Site: Sharnbrook, Watlington, Dorset
High Peak (H2) (H2)

TITLE:
**APPLICATION FOR
PROPOSED DRIVEWAY**

Scale: 1:50
Revision: 02

03_ELEVATIONS

Revised Elevation – as proposed.

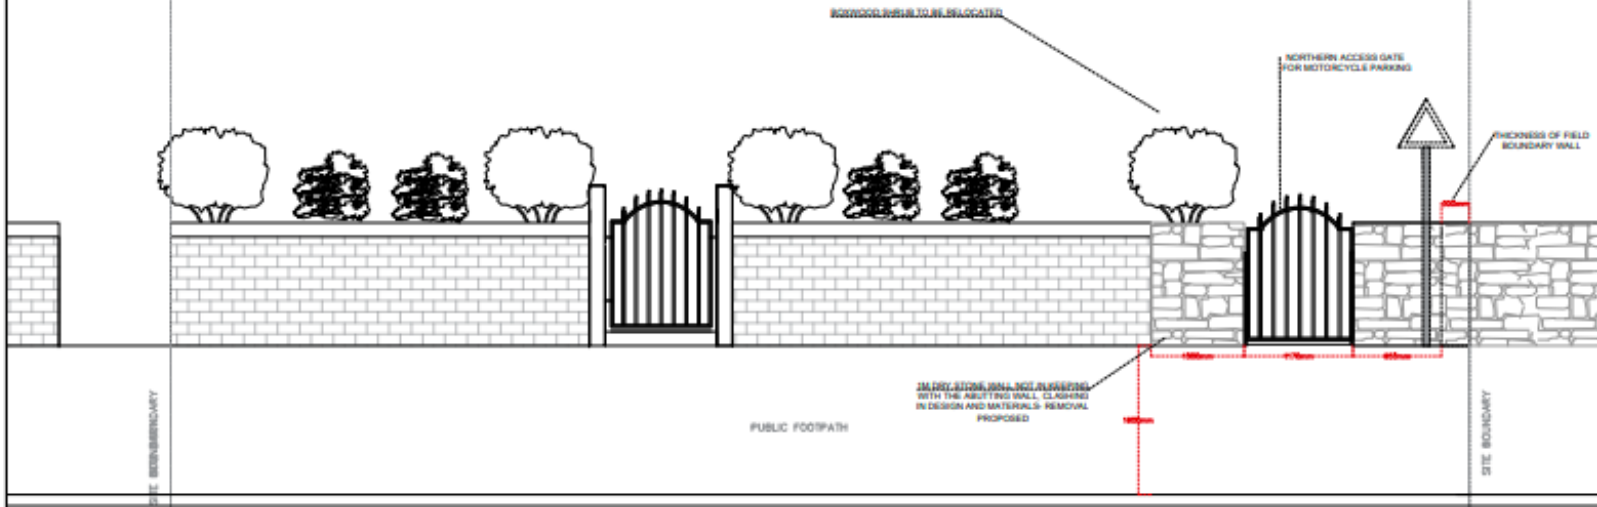
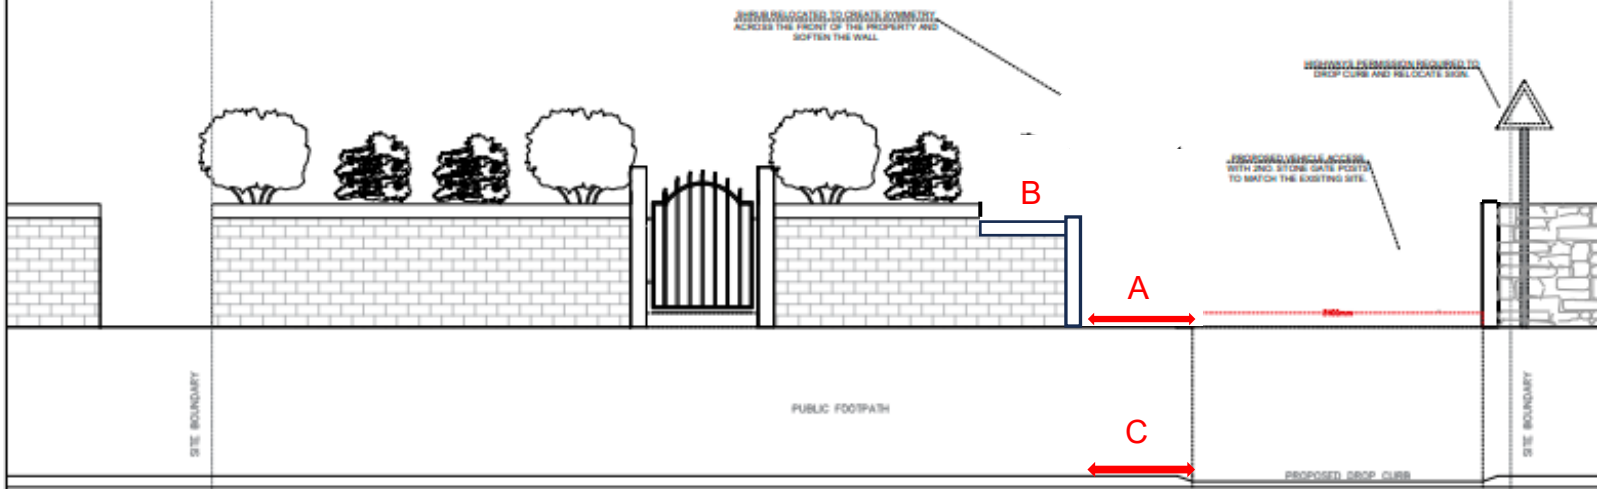
A – Additional 750mm dressed stone wall removed to achieve highway sightline and splay as agreed with DCC Highways

B – 1 meter of coping stone lowered to 900mm to achieve sightline below the required 1.05 m

C – Dropped kerb extended southward by 750 mm
